SUBJECT: **INITIAL COMMENTS LETTER**

PROJECT NAME: FAMILY DOLLAR SALT SPRINGS @ CR 314

PROJECT #2021040075

APPLICATION: MAJOR SITE PLAN #26609

DATE:	04/23/2021
DRAWN BY:	CMB
CHECKED BY:	BMB
PROJECT NO.:	21015
SHEET NUMBER:	C-00

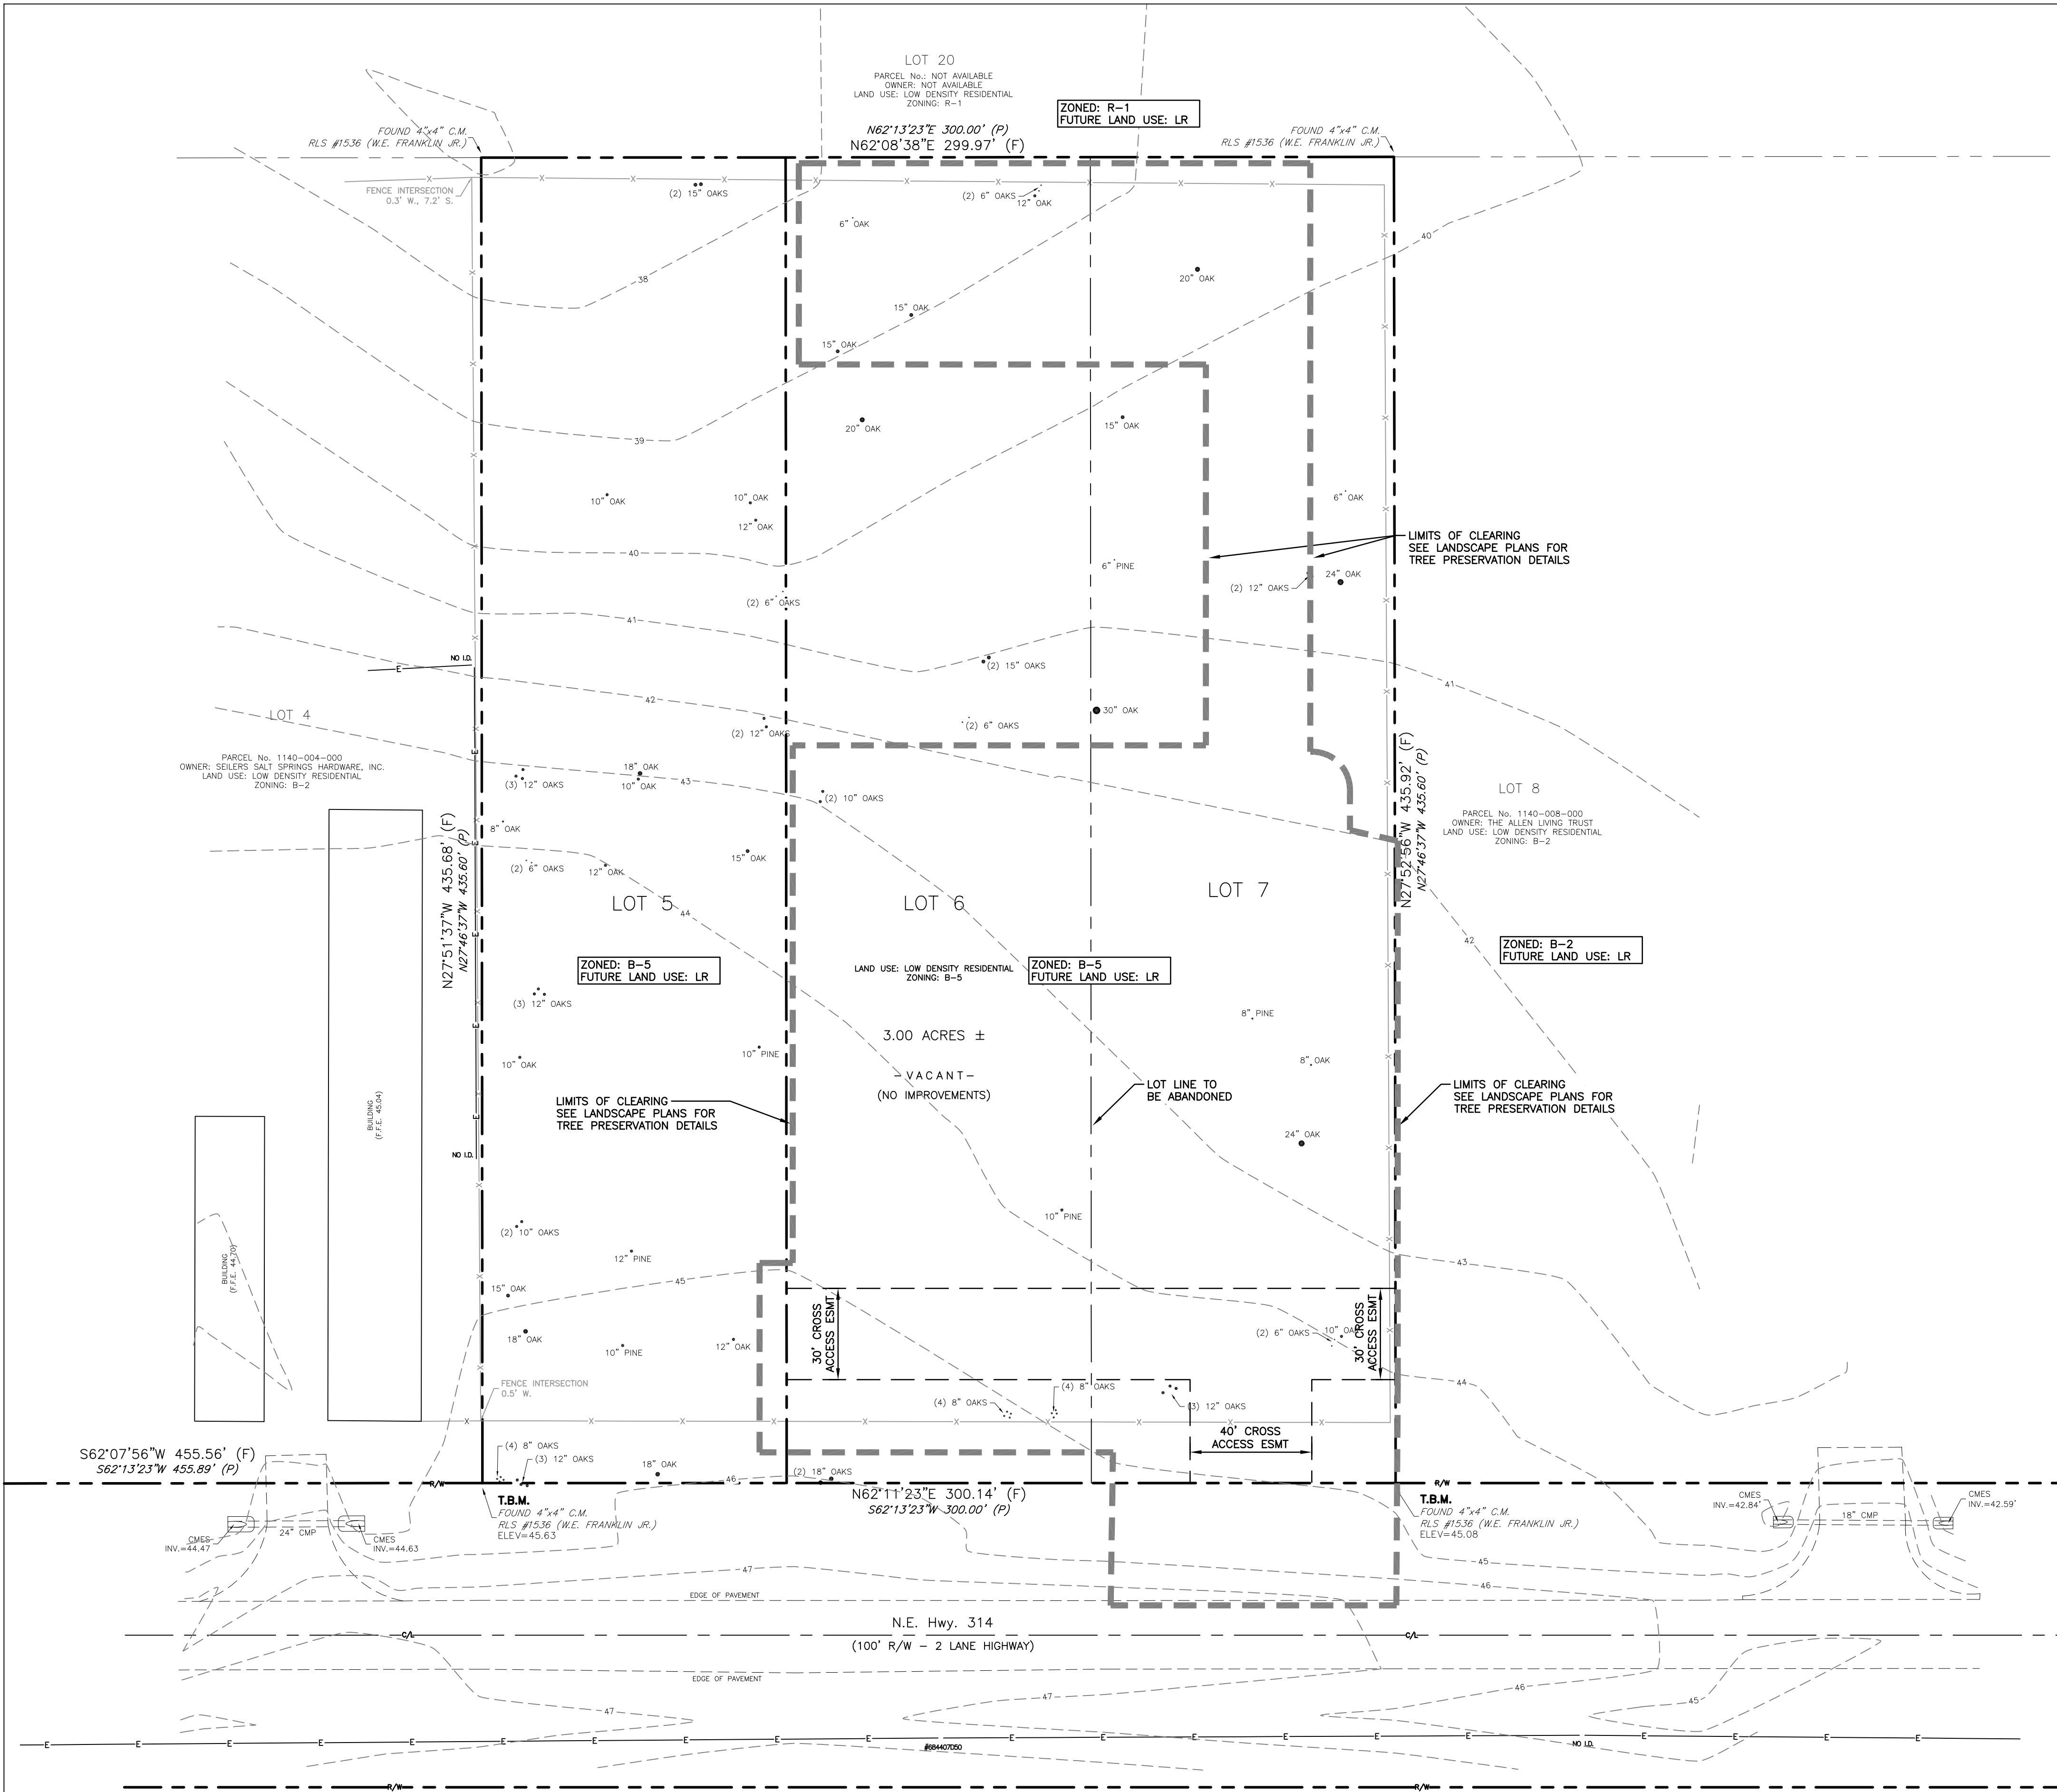
28. DEPARTMENT: ENGIN - DEVELOPMENT REVIEW  
REVIEW ITEM: 2.12.4.L(1) - Parcel number  
STATUS OF REVIEW: NO  
REMARKS: 5/11/21 - Application lists 2 parcel numbers, but plan cover sheet lists only 1 which doesn't match either parcel on application.

33. DEPARTMENT: 911 - 911 MANAGEMENT  
REVIEW ITEM: 2.12.28 - Correct road names supplied  
STATUS OF REVIEW: NO  
REMARKS: Sheet C-00 has incorrect road names in the Vicinity Map. NE County Rd 314 should be NE HWY 314. Forest Rd should be NE 244th Ter. NE 247th Court is north of NE HWY 314, the name changes to NFR 314-16.7 south of NE HWY 314.

35. DEPARTMENT: 911 - 911 MANAGEMENT  
REVIEW ITEM: Additional 911 comments  
STATUS OF REVIEW: NO  
REMARKS: Sheet C-00 has the parcel incorrect as 1140-008-000 under the site data. It should be 1140-005-000, 1140-006-000 & 1140-007-000. Sheets C-01, C-02, C-03.1, C-04, SP-1 & Survey have an incorrect parcel number of 11431-004-00. It should be 11431-000-00.

SHEET NAME:  
DETENTION BASIN  
PLAN

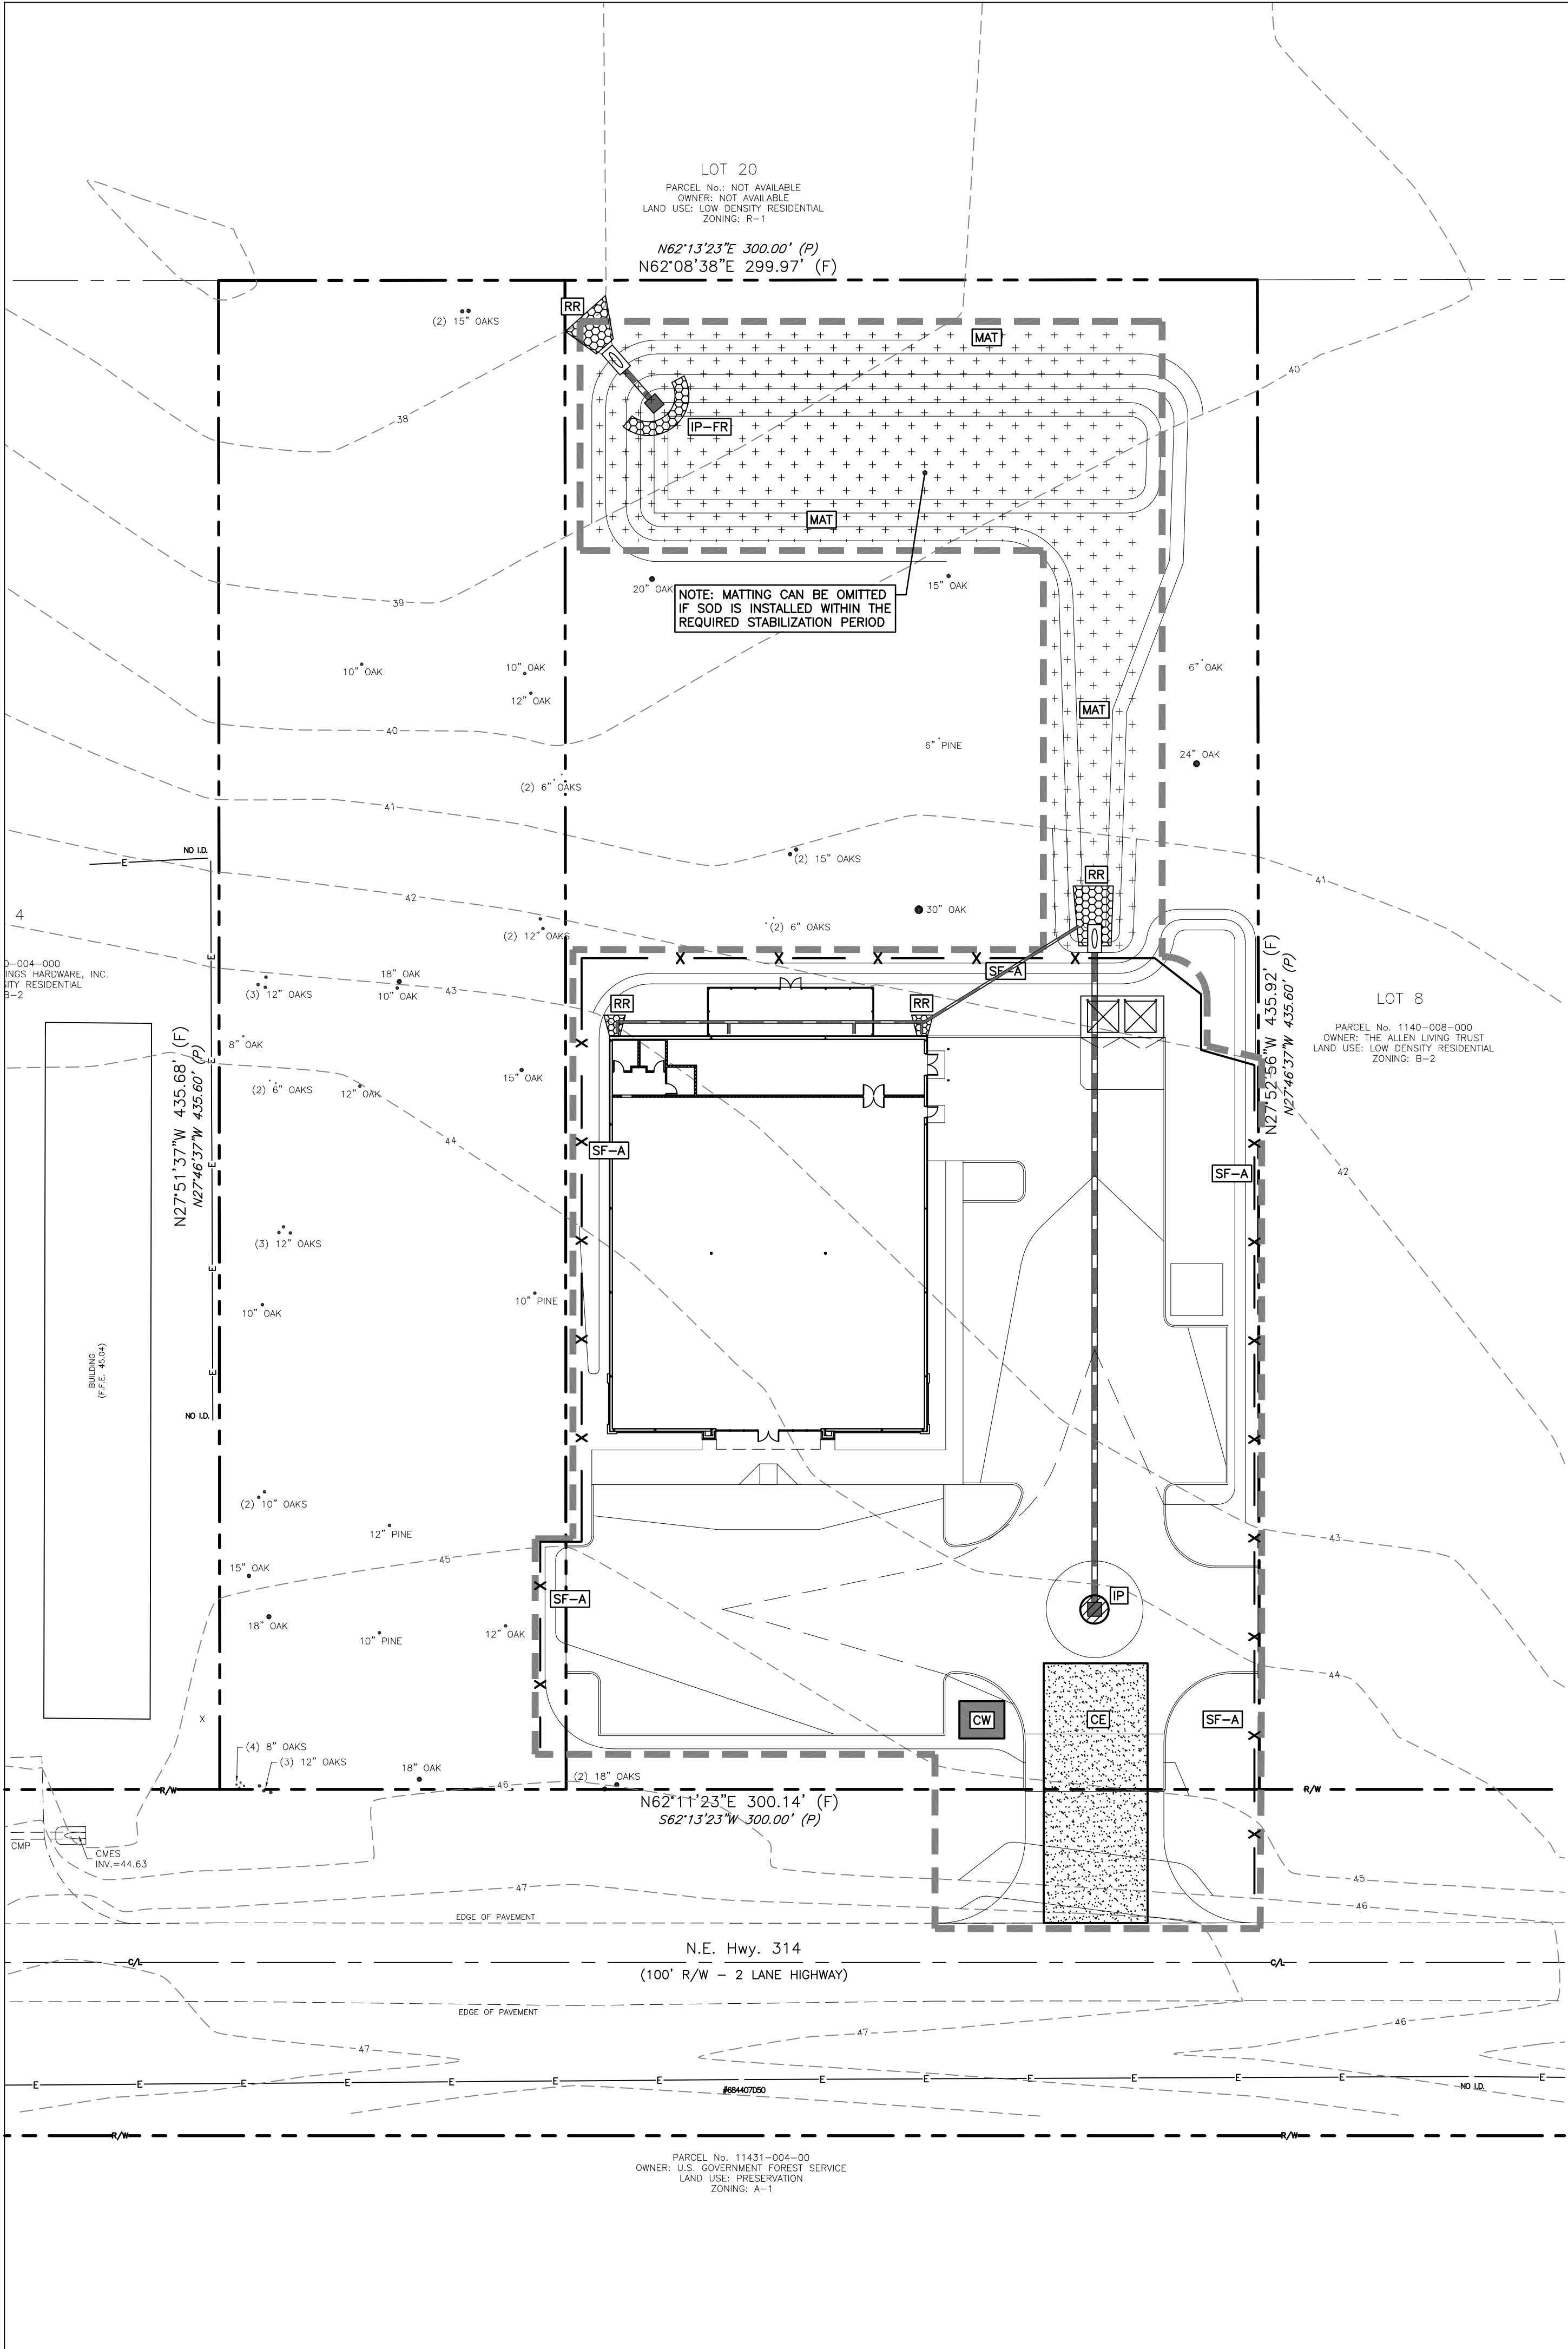
12. DEPARTMENT: ENGDRN - STORMWATER REVIEW  
REVIEW ITEM: 6.13.2.A(3) - Retention/Detention Area Design Parameters  
STATUS OF REVIEW: NO  
REMARKS: 1) Please add dimensions to the DRA. 2) Please show soil boring locations with ID labels on the plans. 3) Please add ESHWT to DRA Cross section detail, and please add pond bottom will be seeded and mulched. Note: If pond is deeper than 4', sodded bottom is required.

15. DEPARTMENT: ENGDRN - STORMWATER REVIEW  
REVIEW ITEM: 6.13.2.B(6) - Freeboard  
STATUS OF REVIEW: NO  
REMARKS: 6" freeboard required in pond.
16. DEPARTMENT: ENGDRN - STORMWATER REVIEW  
REVIEW ITEM: 6.13.8 - Stormwater Conveyance Criteria  
STATUS OF REVIEW: NO  
REMARKS: For the purposes of demonstrating conveyance, a tailwater condition at the receiving body must be assumed in the hydraulic analysis. Please use the peak stage at the 25 year, 24 hour storm as the tailwater condition.
